JL Sweaters Ltd

18th May 2014

Observations

Ground floor plan

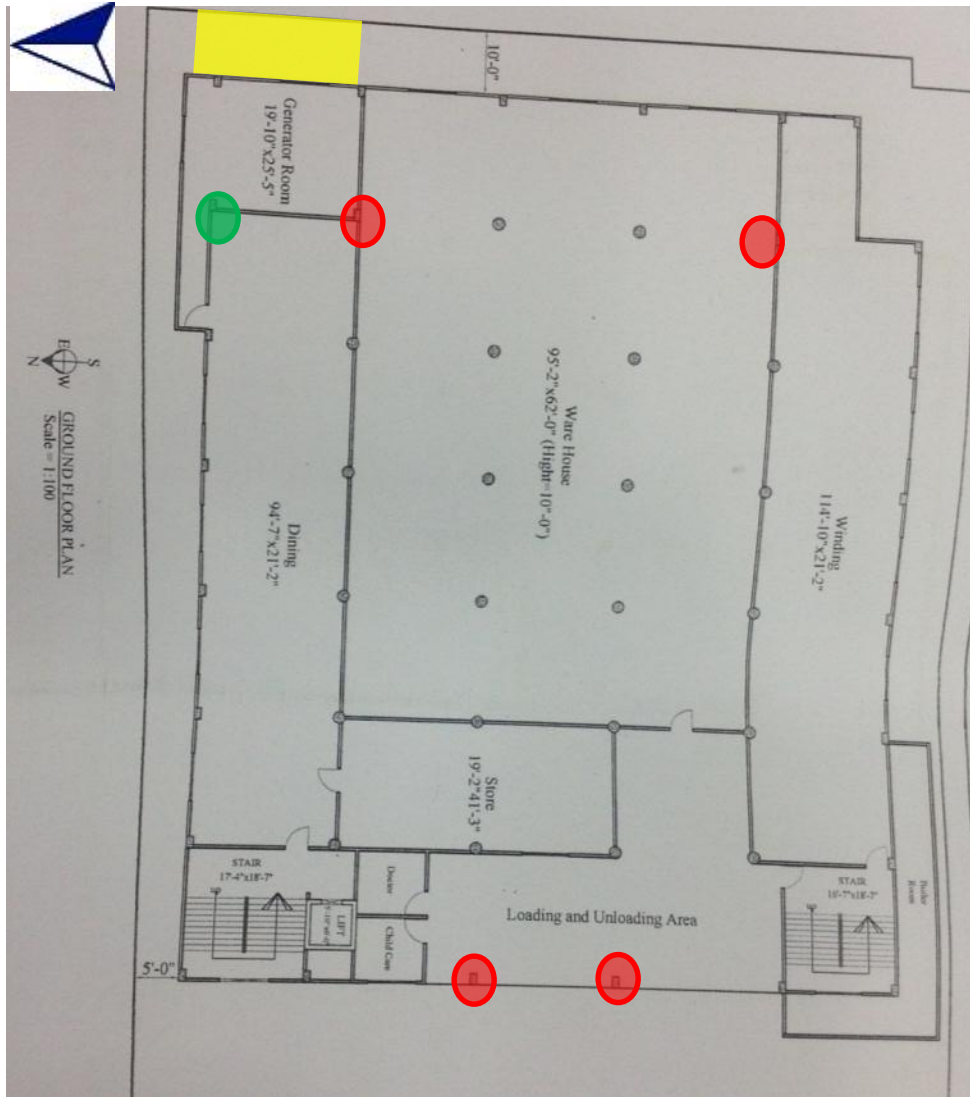
Stress Levels in Columns

- Column investigations indicated stone aggregate.
- Reinforcement was investigated using a ferros scanner.
- Cursory calculations indicate that the working stresses in the columns are at a high level.

Ferrosan columns

Critical Columns requiring immediate action

Item No.	Observation	Recommended Action Plan	Recommended Timeline
1	Stress levels in columns on grid A/1 and A/2	Half of bay between GL A-B is to be completely vacated outside the toilets as shown above at each level, pending verification of column capacity by Building Engineer. Access only to toilets is permitted.	Immediate - Now
2	Stress levels in columns on grid A/1 and A/2	Concrete water tank on roof is to be perforated / provided with weep holes, pending verification of column capacity by Building Engineer.	Immediate - Now
3	Stress levels in columns on grid A/1 and A/2	Building Engineer to review design, loads and column stresses in the area identified plus the toilet area.	Immediate - Now
4	Stress levels in columns on grid A/1 and A/2	Verify in-situ concrete strength either by 100mm dia. cores from min. 4 columns.	Immediate - Now
5	Stress levels in columns on grid A/1 and A/2	Produce and actively manage a loading plan for all floor plates within the Main Factory Building, giving consideration to floor capacity and column capacity.	6-weeks
